Thor Motor Coach Recall Repair Instructions

Recall # 13V-265/ 2013-217 (Canada)

Description/Title: **RV Custom Product FW-2050 Battery Control Center**

Service Campaign # : **RC000077**

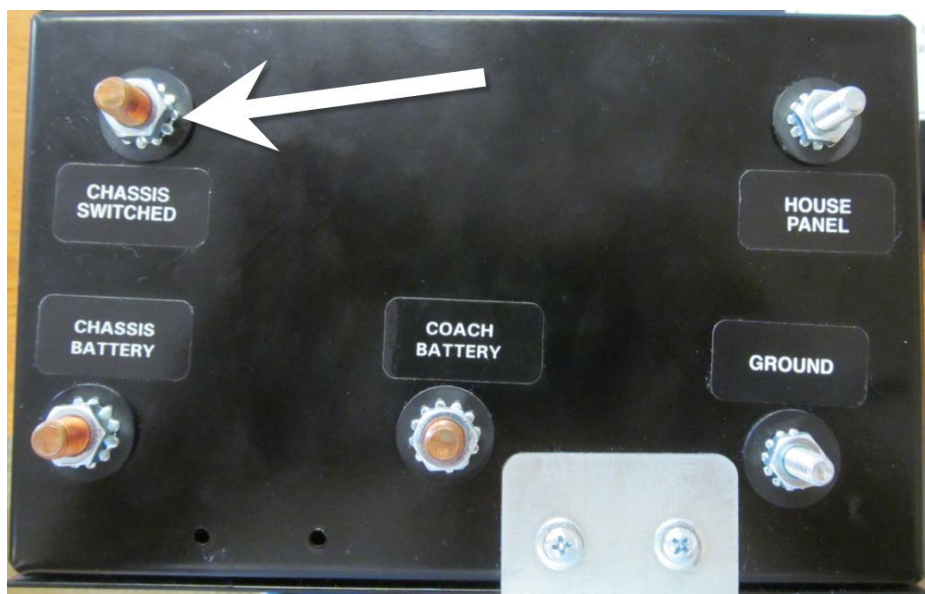
SUMMARY: On certain gas Class A units with the RV Custom Products FW-2050 Battery Control Center (BCC) there may be an issue with the chassis battery disconnect.

CONSEQUENCE: May cause loss of power to the chassis while driving causing the lights and/or other chassis components to cease functioning.

REMEDY: The chassis battery disconnect function will be bypassed. **This function will no longer work on the vehicle after the recall is performed.**

1. Locate the FW-2050 Battery Control Center. It should be under the hood, usually on the driver's side.
2. Disconnect the Chassis Battery and Cable at the Battery
3. Verify that the House Battery Disconnect is turned OFF.
4. Verify that the coach is NOT plugged in.
5. Verify that the generator is NOT running.

6. Remove the battery cable from the “Chassis Battery” post on the left hand side of the BCC.

7. Place the cable you just removed from the “Chassis Battery” post onto the post labeled “Chassis Switched”.

8. Tape off the “Chassis Battery” post.

9. Reconnect chassis battery and cable at the battery.
